**ADDENDUM #1**  
**CENTRAL COMMUNITY COLLEGE**  
**Howard Building Remodel**  
**HASTINGS, NEBRASKA**  
**1322**

Wilkins Hinrichs Stober Architects, L.L.C.  
2908 West 39<sup>th</sup> Street, Suite A  
Kearney, Nebraska 68845  
308-237-5787

Date Issued: May 30, 2013

1  
A1

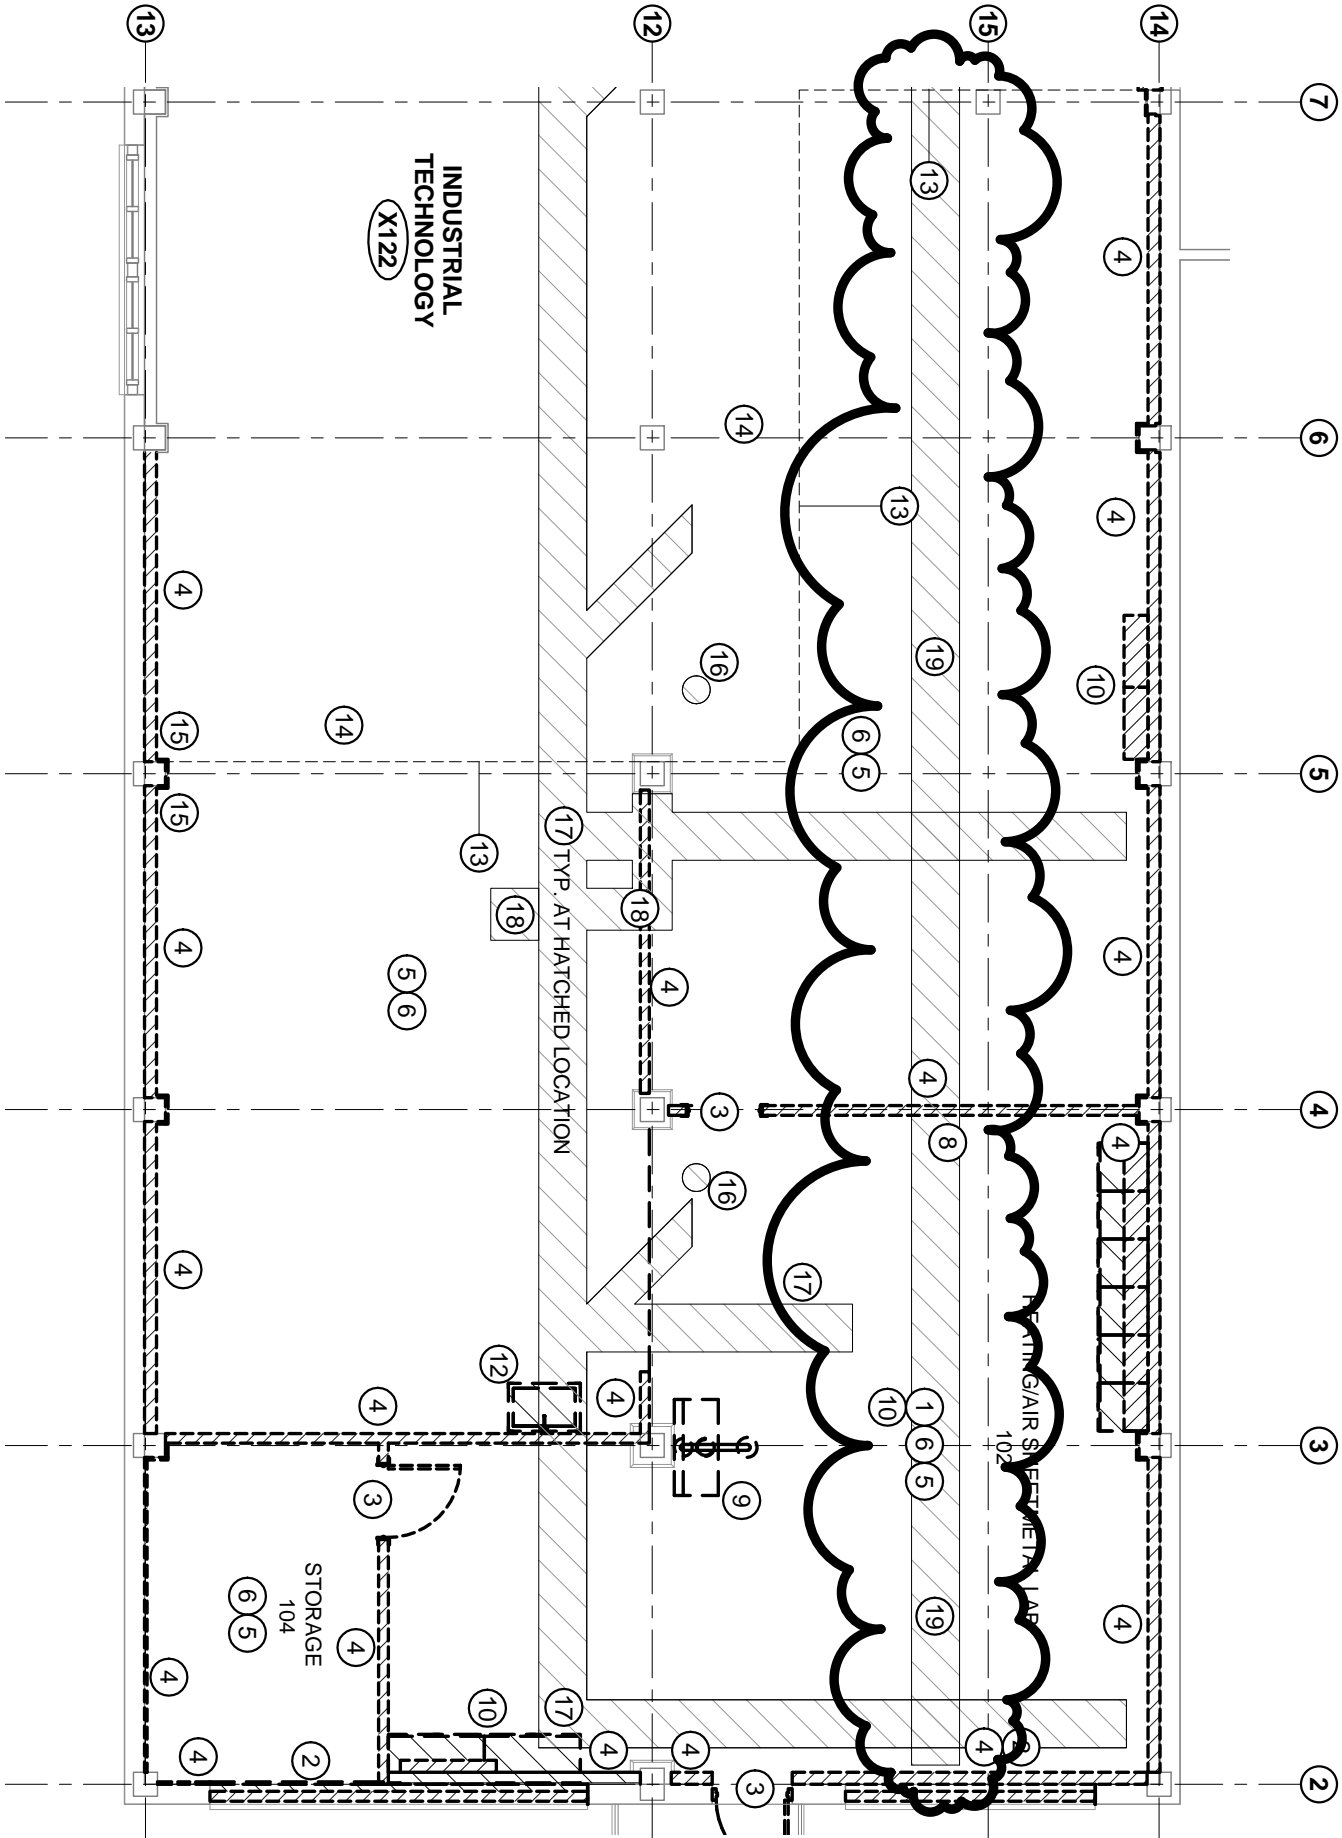
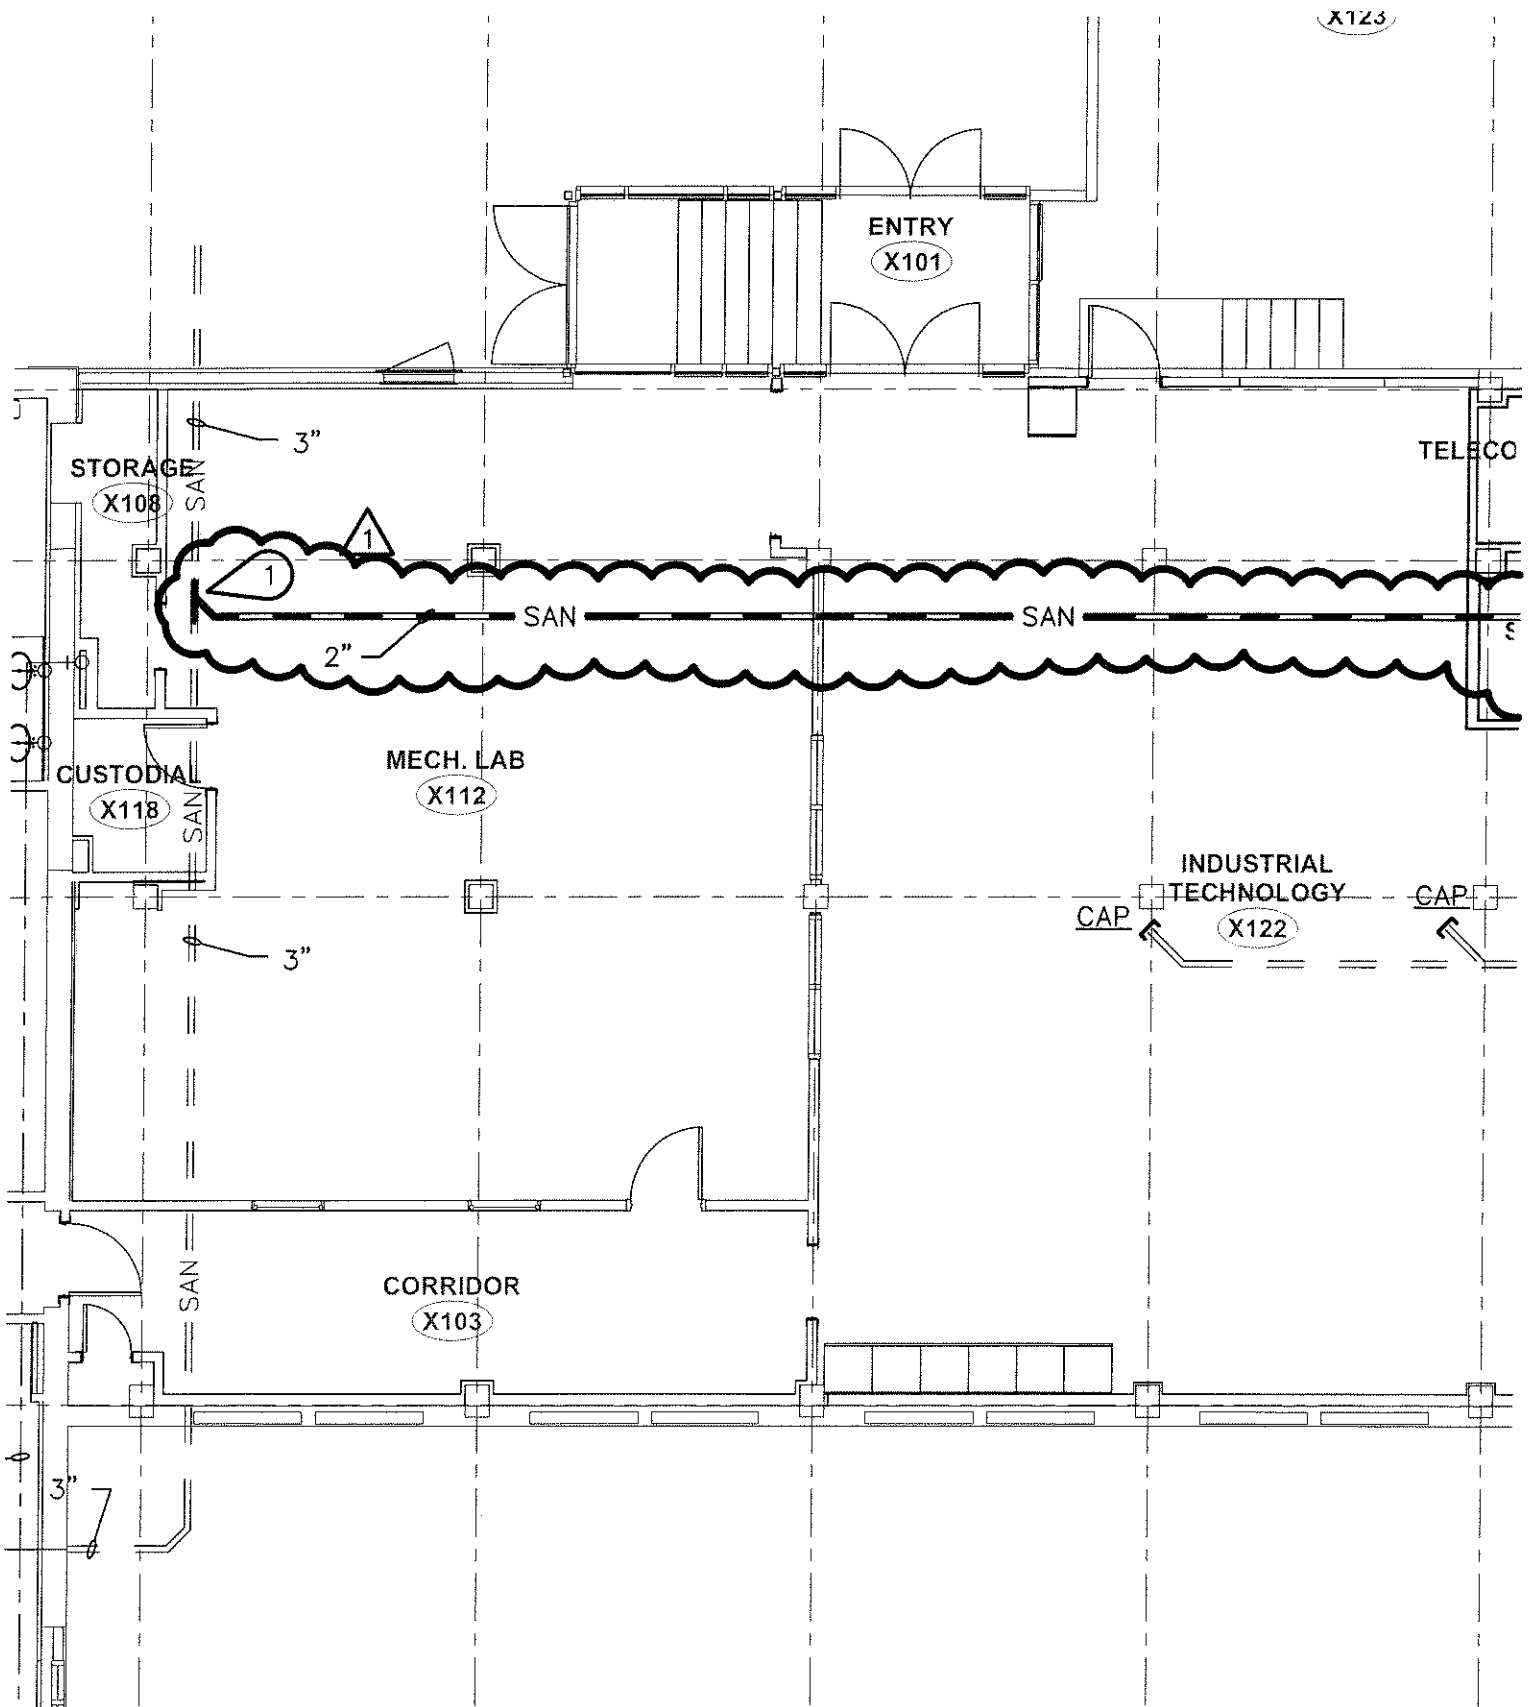
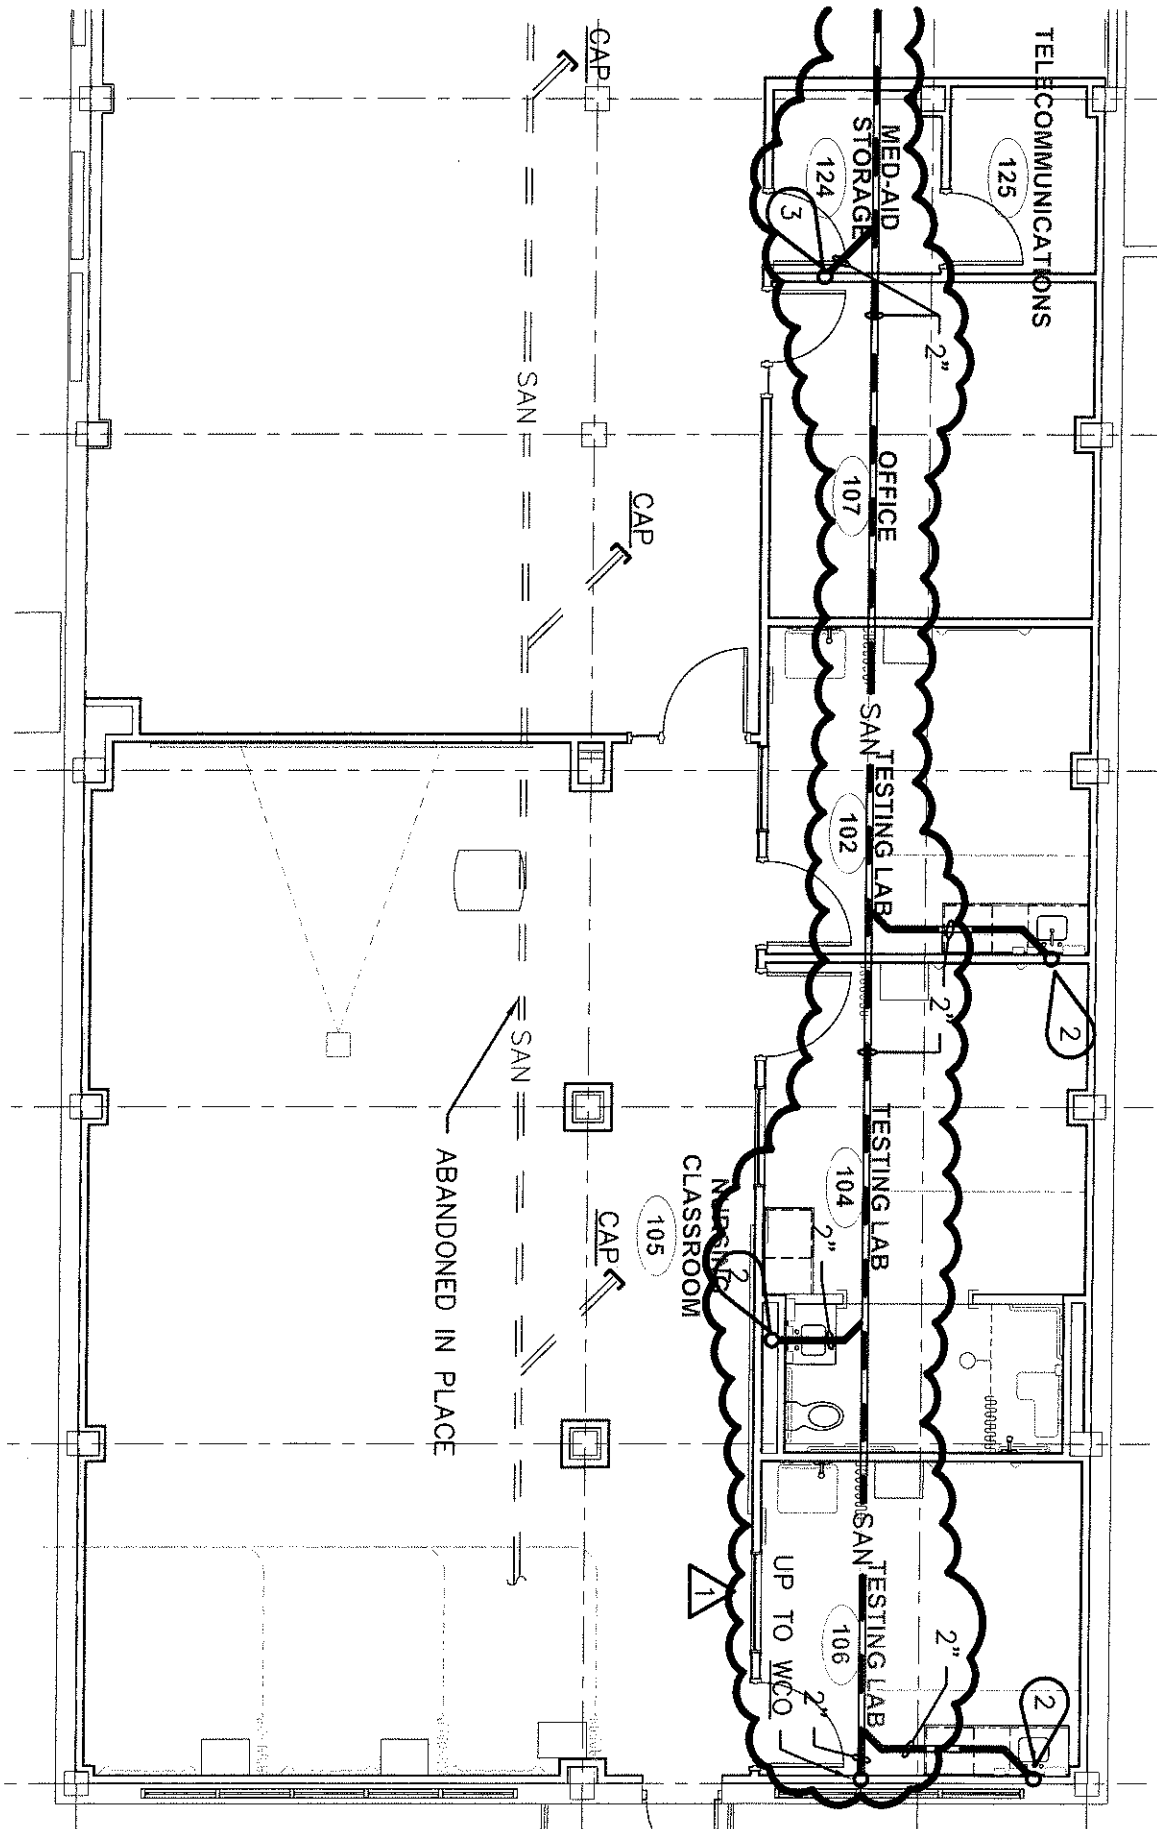
- Addendum #1 - #8 SHEET AD1.0 – DEMOLITION FLOOR PLANS**  
See attached supplemental drawings A1 and A2 for additional concrete needing removed and replaced to accommodate new sanitary line.
